Addendum to Urban Design Brief dated December 23, 2021 130-142 Victoria Street South, Kitchener

Official Plan and Zoning By-Law Amendment Applications:
OPA22/004/V/KA & ZBA22/006/V/KA

Prepared for 1936026 Ontario Inc.
by Arcadis Professional Services (Canada) Inc.
June 14, 2023

Figure 8: Preliminary Landscape Plan prepared by STUDIO tla Landscape Architects

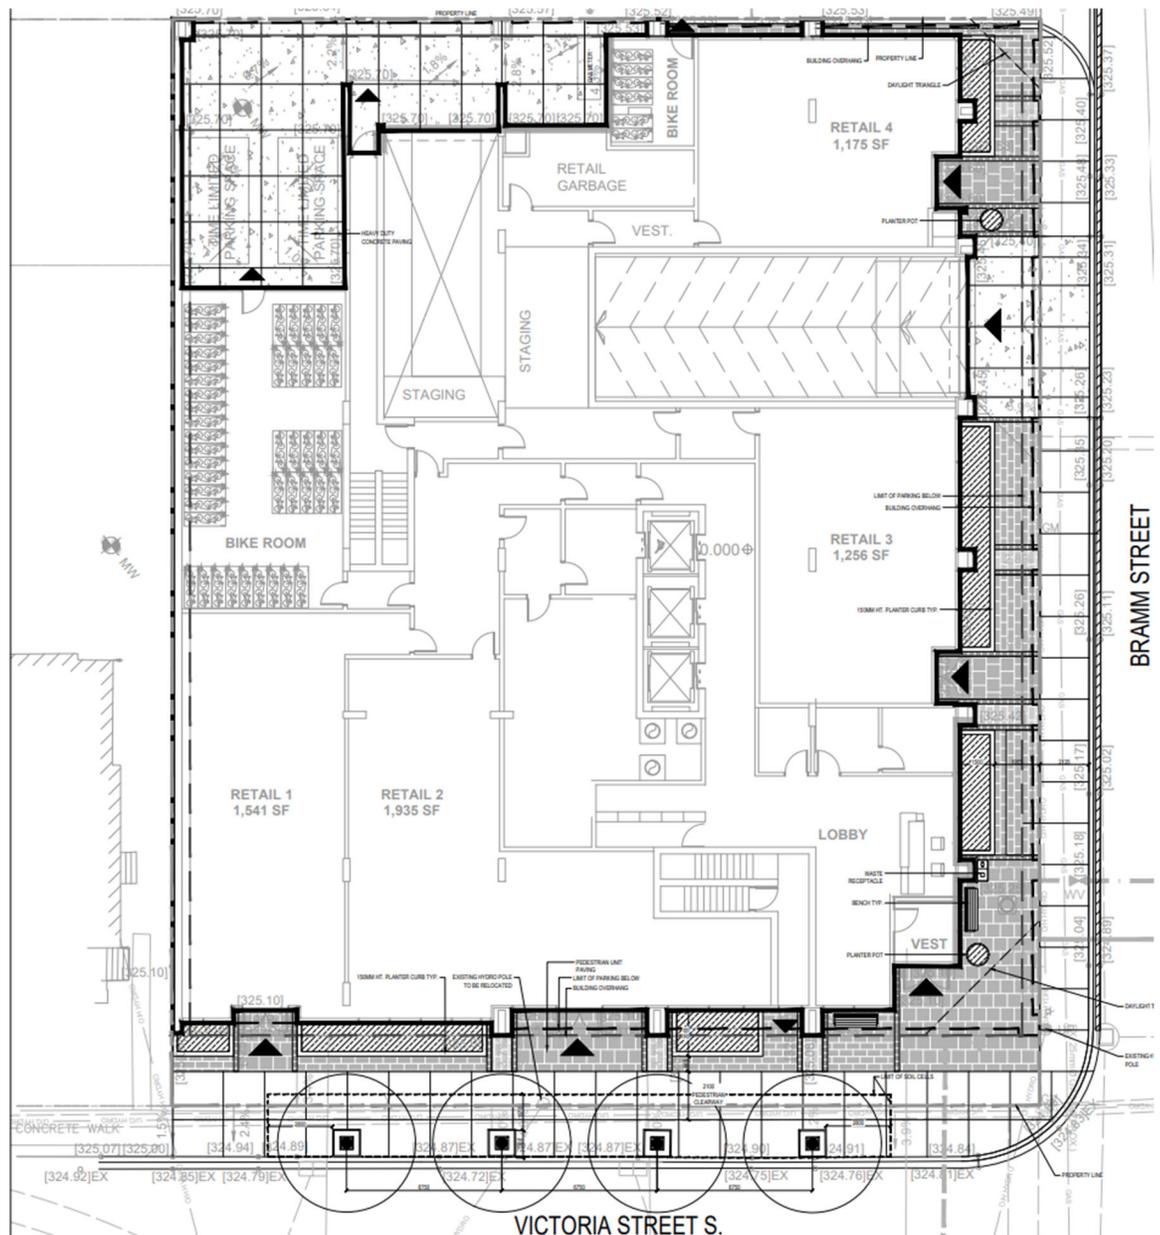
- *Details of the streetscape are to be provided. Any streetscape elements proposed are to be reviewed and approved.*

- *The area between the building's face and the property line should be well integrated with the street and public realm to deliver high-quality and seamless private, semiprivate and public spaces.*

The applicant has prepared an updated preliminary Landscape/Streetscape and Amenity Plan as part of this resubmission package. Based on the plans prepared and shown in Figure 8 below, the Victoria Street South frontage will include four (4) trees, as well as planters along the side of the proposed podium. Similarly, Bramm Street will include planters along the flankage and planter pots. Due to insufficient space along Bramm Street, the applicant cannot include trees along this side of the proposed development. Two (2) benches are also proposed adjacent to the building lobby.

It is our opinion that the proposed development will feature a streetscape that is attractive and inviting for pedestrians. It is our opinion that the proposed soft and hard landscaping at-grade will enhance both Victoria Street South and Bramm Street, creating a pedestrian-oriented environment. Further design details pertaining to the Landscape/Streetscape and Amenity Plan will be addressed at the Site Plan Approvals stage.

As mentioned above, the proposed Preliminary Landscape Plan proposes a number of soft and hard landscaping features between the buildings face and public realm. For example, planters are proposed along the Victoria Street South frontage and Bramm Street flankage. Planter pots and benches are also proposed to enhance the streetscape. Interlocking pedestrian pavers are proposed along the perimeter of the site in order to provide an aesthetically pleasing walkway for pedestrians. It is our opinion that these at-grade features will foster a strong relationship between the public and private realm. Please refer to the Preliminary Landscape Plan prepared by STUDIO tla Landscape Architects for reference.

Figure 9: Amenity Plan prepared by STUDIO tla Landscape Architects

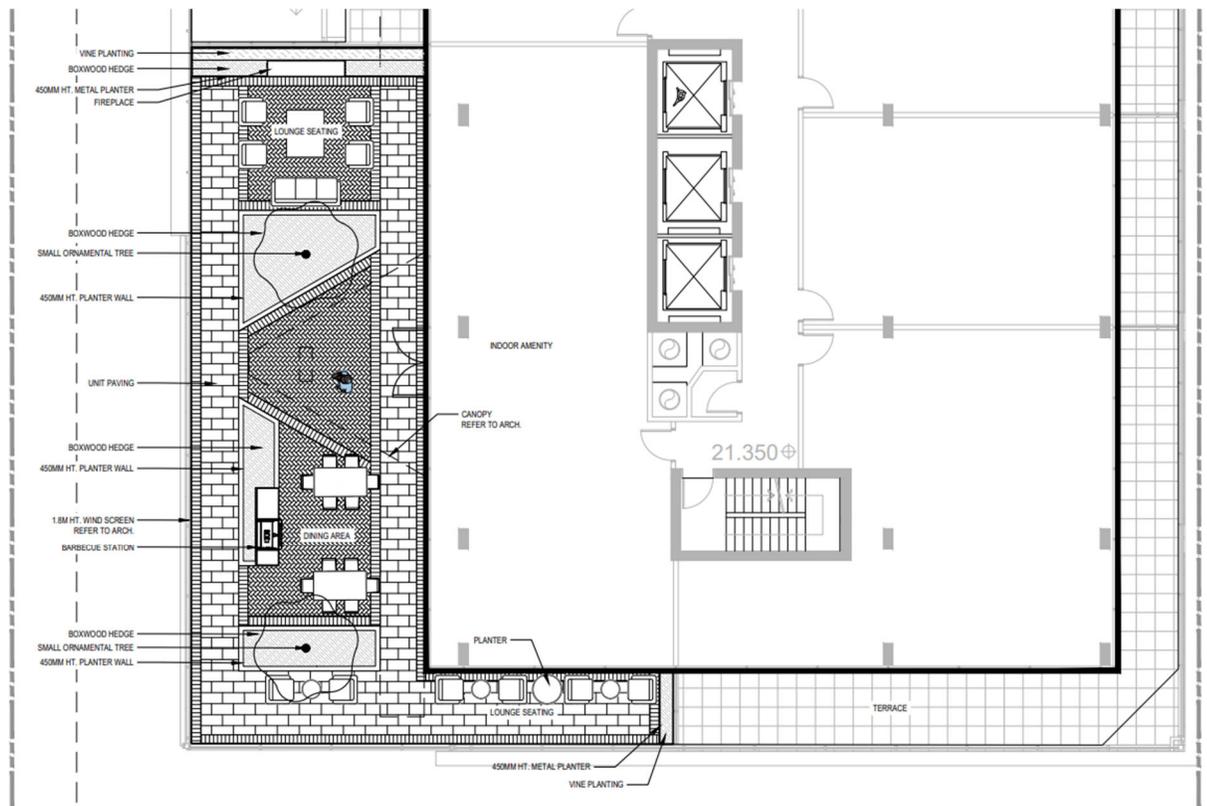
- *The Urban Design Brief indicates that there will be on-site amenity spaces provided on the podium level but few details of the anticipated amenities have been provided. It is understood that the detailed landscape design for the site is not complete at this time but the Urban Design Brief should be updated to include a clear commitment to providing a robust on-site outdoor amenity space with good solar access and protection from wind and noise. The amenity space should include seating and play equipment for residents of all ages and abilities. Precedent images should be provided. The functionality, inclusivity and range of amenities in these private spaces will be critical for the development and the noise assessment, pedestrian wind and solar access assessments should be utilized as key factors in the detailed design or the project.*

As previously noted, the proposed development will have a six (6) storey podium that features an outdoor amenity space on top for future residents. The proposed outdoor amenity space is approximately 191.96 sq.m. (2,067 sq.ft.) in size, and will feature both soft and hard landscaping, which is detailed in the Amenity Plan prepared by STUDIO tla Landscape Architects. The outdoor amenity space will feature hedges, vine planting, and two (2) ornamental

The proposed outdoor amenity space will feature lounge seating throughout, a dining area with a barbeque station, as well as a fireplace. Windscreens are also proposed in order to mitigate any adverse impacts from the wind. From an architectural perspective, the exterior amenity space will also feature a canopy above the entrance/exit that is of similar design as the existing canopy on 130 Victoria Street South (Victoria Wellness and Pharmacy). The proposed outdoor amenity space is also adjacent to the indoor amenity space on Level 7, thus providing a seamless transition between the indoor and outdoor amenity space for residents.

Figure 9 below provides an illustration of the Amenity Plan prepared by STUDIO tla Landscape Architects.
